Editing Instructions: Replace Subclause 142.2 with the following. Note this document shows changes from CI 142.2 via MS Word mark-up.

142.2 Physical Coding Sublayer (PCS) for 100G-EPON

Figure 142- 2 Transmit/Encode State Diagram

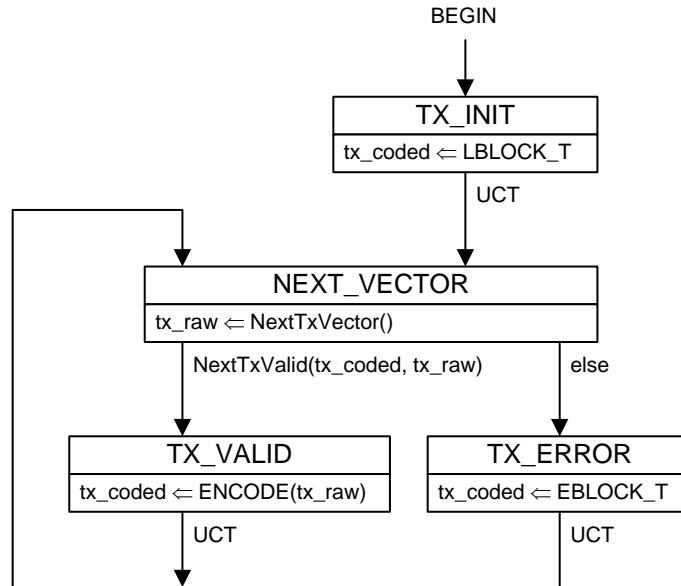
The OLT and the ONU shall implement the Transmit/Encode process as depicted in Figure 142- 2.

Figure 142- 3 ONU Synchronizer state diagram

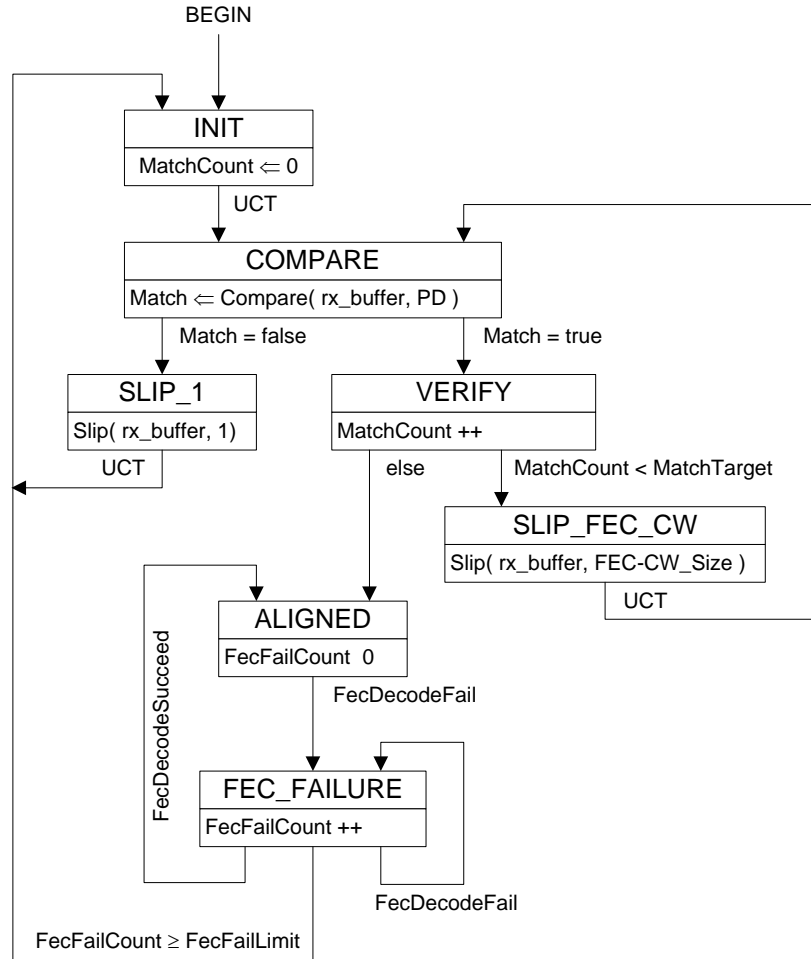
The ONU Synchronizer shall implement the state diagram as depicted in Figure 76–20.

Figure 142- 4 Receive/Decode State Diagram.

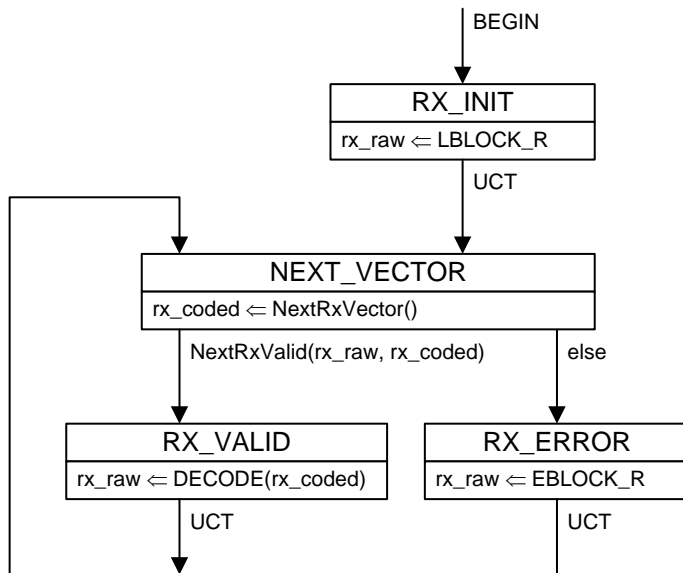
The OLT and the ONU shall implement the Receive/Decode process as depicted in Figure 142- 4.
